# PLANNING REPORT

## Planning & Zoning Commission

# Penzone Live-Work Building 24-077PDP | 24-078FDP

Address	PID: 273-0009121
Proposal	Preliminary Development Plan (PDP) and Final Development Plan (FDP) for construction of a live-work building and public art park on the existing Penzone campus.
Request	Request for review and approval of PDP and FDP under the provisions of Zoning Code Section 153.053.
Zoning	BSD-SCN – Bridge Street District Sawmill Center Neighborhood
Planning Recommendation	<u>Approval of Waivers</u> <u>Approval of PDP and FDP with conditions.</u>
Next Steps	Upon approval of the Waivers, PDP and FDP, the applicant may work with staff to meet the conditions of approval. Subsequently, the applicant may apply for permits through Building Standards.
Applicant	Zach Zaworski, Meyers + Associates Chris Meyers, Meyers + Associates
Case Manager	Rati Singh, Assoc. AIA, Planner I (614) 410-4533 <a href="mailto:rsingh@dublin.oh.us">rsingh@dublin.oh.us</a>

### Street Network, Lots, and Blocks

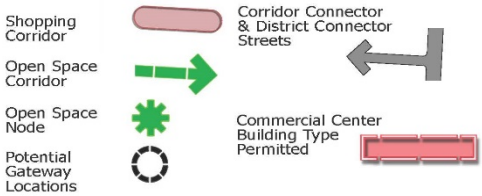
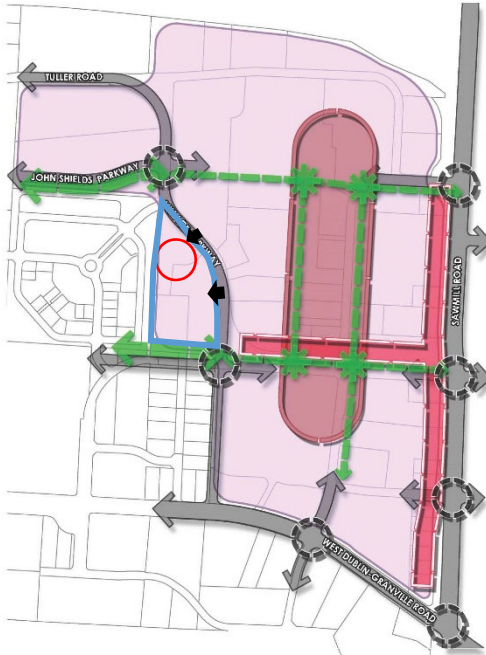
The site is oriented toward Village Parkway, which is designated as a District Connector and Principal Frontage Street (PFS). PFS designated streets are designated to ensure a continuous, pedestrian-oriented block. The entire Penzone site (highlighted in blue on the map to the right) currently includes 2 vehicular access points centrally located on the east side of the site. This proposal would not modify the location and number of access points on the site.

Site Plan

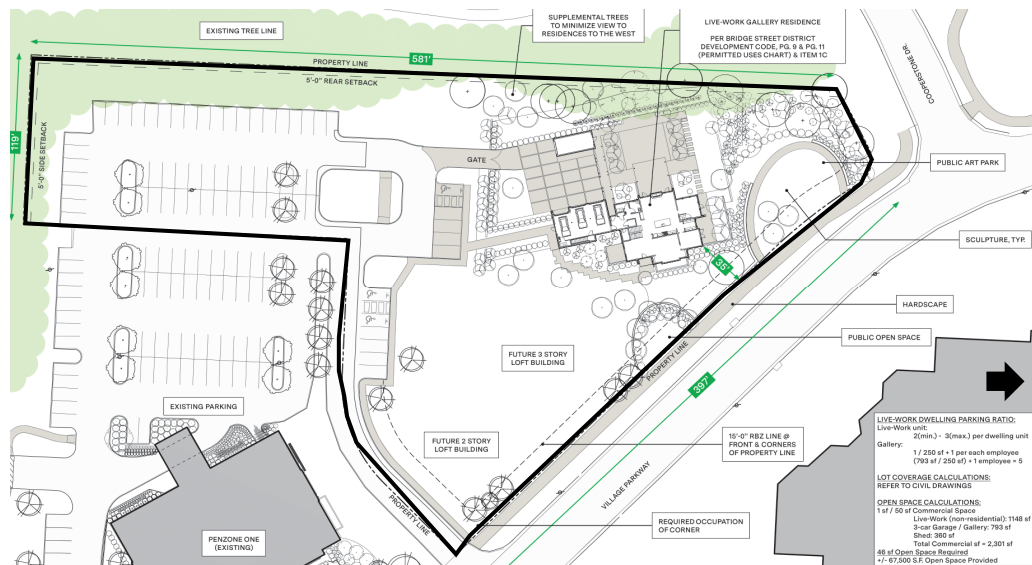
Based on the Commission’s feedback and the conditions of approval at Concept Plan, the applicant has relocated and reoriented the building, bringing it closer to Village Parkway to better meet the intent of creating an urban form on the site and blending the building design into the public park. This would allow for integration of pedestrian circulation with Village Parkway, and better address the Village Parkway frontage.

The 2,978-square-foot Loft building with an attached garage is now sited at an angle in the northeast portion of the parcel at a setback of approximately 35 feet from Village Parkway. The Public Art Park and public open spaces are located along Village Parkway. The outbuilding is located along the western side of the site. Pedestrian and vehicular access is provided from an existing access drive east of the site. A gated private drive is proposed on the west side to access the live-work unit, which will be used by the residents. A 4-foot high fence will be installed along the west property line for privacy purposes. The southeast portion of the site is intended to be used for future development.
